Addendum #2

Lewiston Readiness Center POV Parking Addition

Project No. 23SC16-306, Bid Number #20-036

31 March 2020

SHEET ID:
 CP101
 SHEET: 1 OF 1

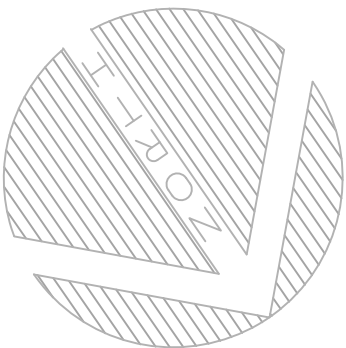
ADDENDUM 2 NOTES:

1. SEE DETAIL C-3/C-403 FOR NEW TO EXISTING INTERFACE.
2. EDGES OF PAVEMENT STRAIGHTENED OUT TO PROVIDE A CLEAN EDGE.
3. EROSION CONTROL MEASURES SAME AS IN BASE BID SEE SHEET C-102.
4. PAVEMENT DETAIL CAN BE FOUND IN DETAIL C-103.
